Product Update

Title: Update firmware for the Smart IP Access

No: 200709-01

Summary: Smart IP Access firmware was recently updated to include product operation enhancements.

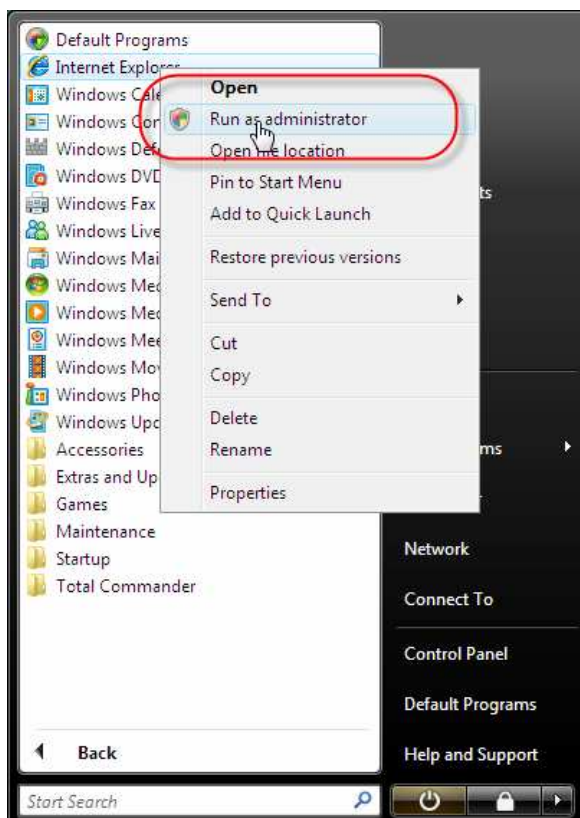
- Added support for Microsoft Windows Vista on a client computer:

To connect to the Smart IP Access from Windows Vista, the user must run the Internet Explorer as Administrator. To do this you need to right click on the explorer icon on the task bar and select to run the Internet Explorer application as administrator.

Look at the image below: (note: type the administrator's password when prompted)
